REACTOR FACILITY

Re: Request for Additional Information (TAC No. M90497)

This is a response to an NRC request dated September 10, 1996 for additional information concerning a proposed revision to the Reed Reactor Facility Emergency Plan. The paragraph in question is reproduced below:

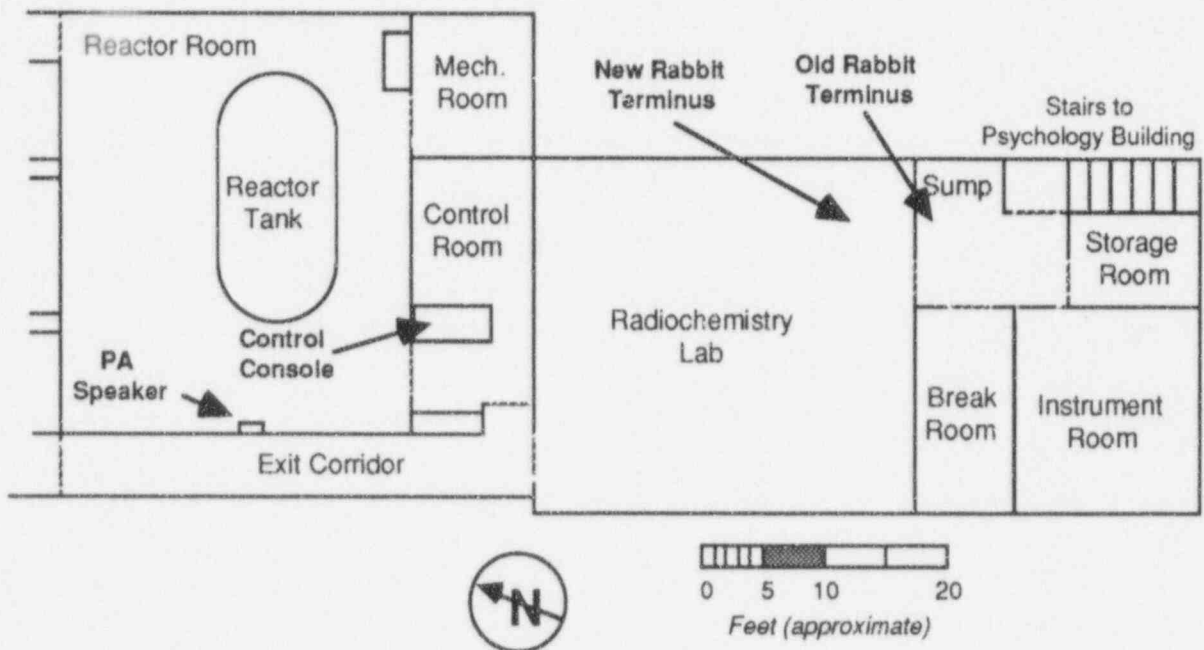
1. Explain the locations, functions, capabilities and emergency uses of the intercom system.

The intercom was used for communication between the reactor operator at the control console and the pneumatic transfer system operator at the pneumatic transfer system terminus. The pneumatic transfer system is commonly referred to as the "rabbit" and that terminology will be used here. As can be seen in the enclosed floor plan, the old rabbit terminus was two rooms away from the control console with three doors in between. The intercom was necessary to allow the reactor operator and the rabbit operator to coordinate inserting and removing rabbit samples to and from the reactor. The intercom was originally a two station wired push-to-talk off-the-shelf system. Several years ago that system failed and was replaced by a wireless headset arrangement sold by Radio Shack. Since the rabbit terminus was removed in 1992 as part of extensive renovations, the headsets have been used for other purposes. The intercom never served any emergency function; it was listed in the Emergency Plan for completeness as another possible form of communication.
